In Reply Refer To:
HSSD/WZ-231

Thank you for your letter of October 12, 2006, requesting the Federal Highway Administration’s (FHWA) acceptance of your company’s FG300 EFX Series channelizer post mounted to a 35 pound portable rubber base as a crashworthy traffic control device for use on the National Highway System (NHS). Accompanying your letter was background information regarding informal tests conducted. You requested that we find this device acceptable for use on the NHS under the provisions of the National Cooperative Highway Research Program (NCHRP) Report 350 “Recommended Procedures for the Safety Performance Evaluation of Highway Features.”

A drawing of the proposed FG300 EFX Series channelizer post mounted to a 35 pound portable rubber base is enclosed. The complete assembly is comprised of the following components:

PART NAME		
FG-348 FYG EFX W/ 800BASE145		
DEPT. HEAD	ENGINEERING MANAGER	DATE

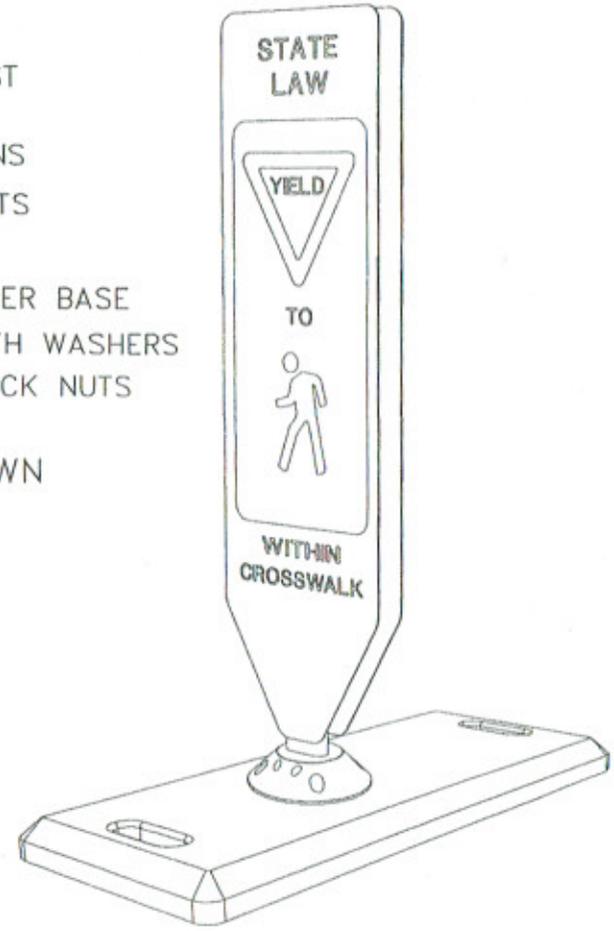
Based on our records of successfully crash tested vertical panels, equivalent designs such as yours are inherently safe. Therefore, lightweight vertical panels with no lights attached, mounted to a flexible or a low-profile weighted base, and with a top panel height measuring no more than 48 inches, are now accepted by the FHWA as a Category 1 device and may be self-certified by the vendor. Delineators are Category 1 devices as well. As a reminder, crash testing is still needed to determine the FHWA acceptance of vertical panels with lights attached.
